STERLING RANCH - VOLLMER ROAD
NOTES AND DETAILS

**STERLING RANCH -
VOLLMER ROAD
PLAN & PROFILE**

STERLING RANCH - VOLLMER ROAD CROSS SECTIONS

**STERLING RANCH -
 STERLING RANCH ROAD
 STREET SECTIONS**

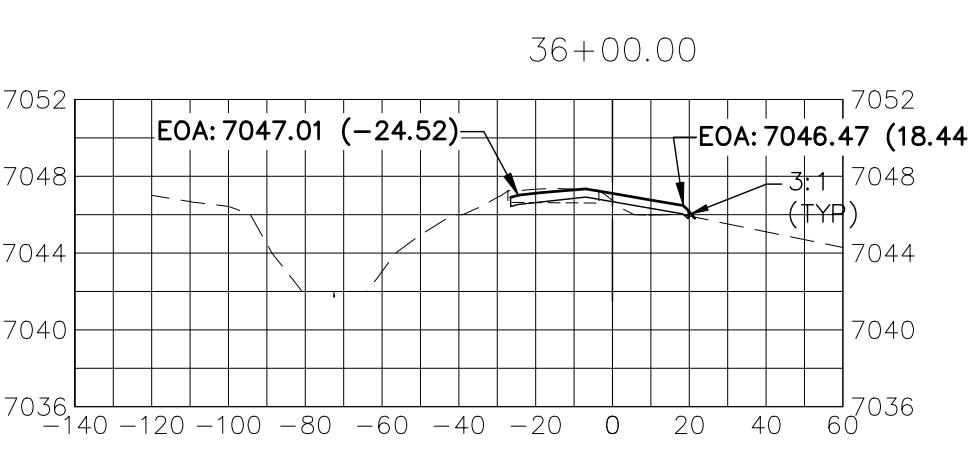
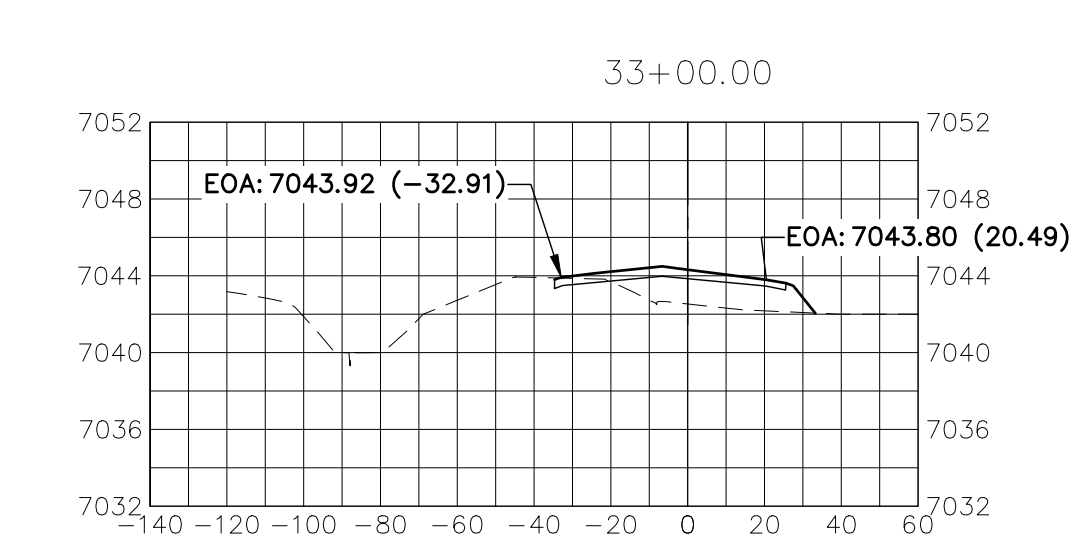
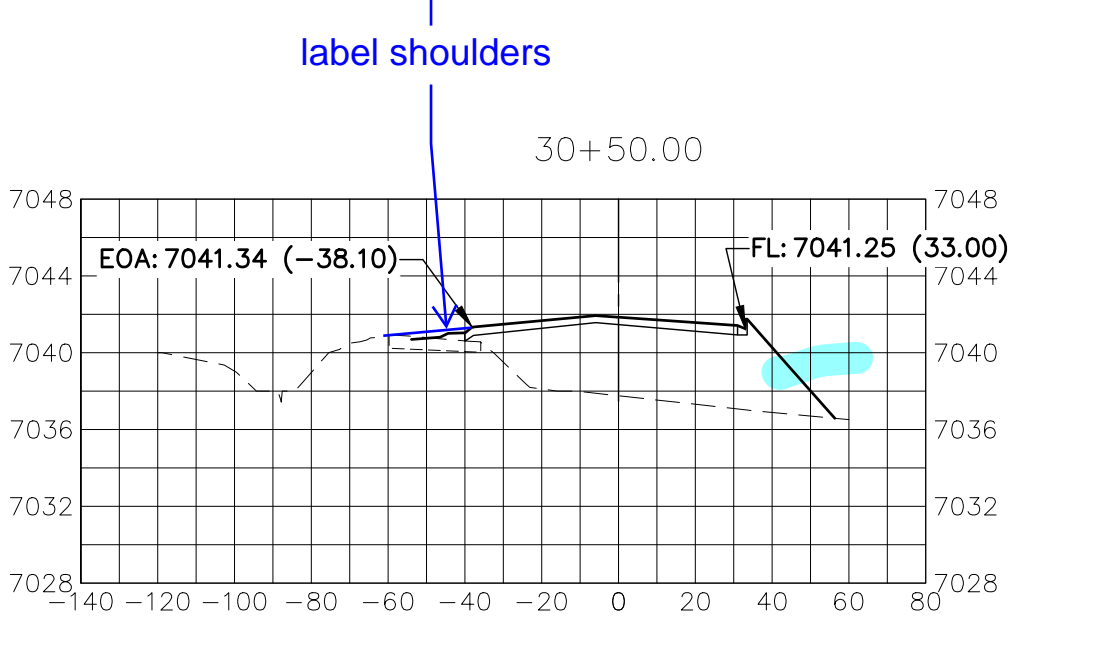
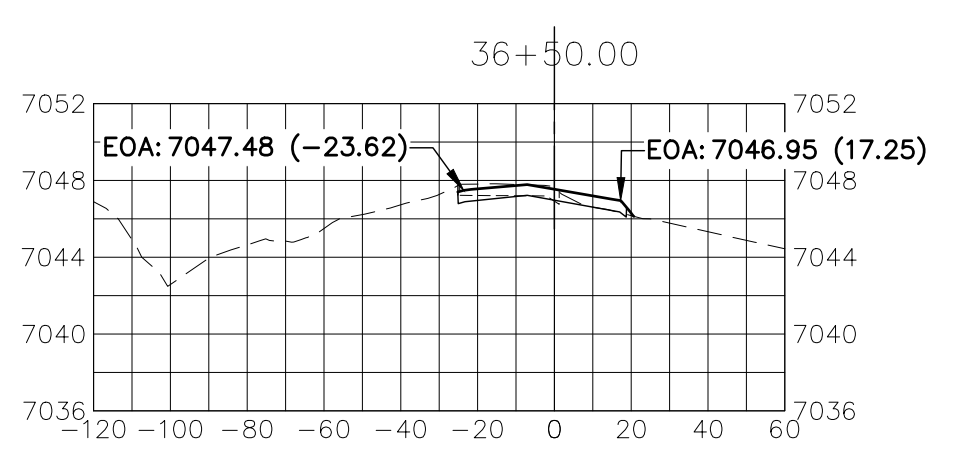
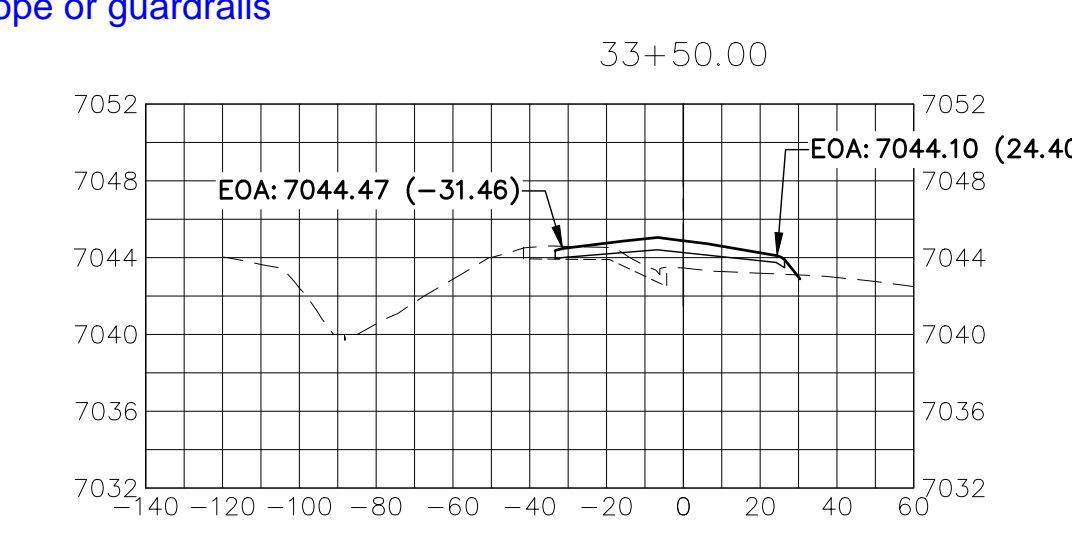
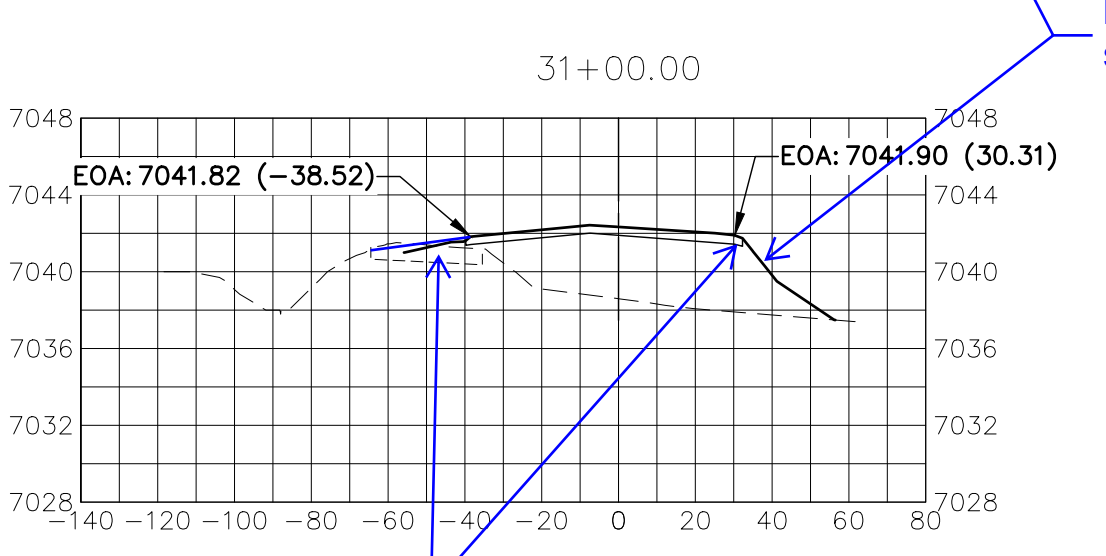
Provide shoulder and ditch dimensions from, or copy of, SD_2-12 for segments without curb and gutter.

grade shoulders to drain

label max cross-slope 5:1 for 12.5'

label recoverable slope or guardrails

label shoulders
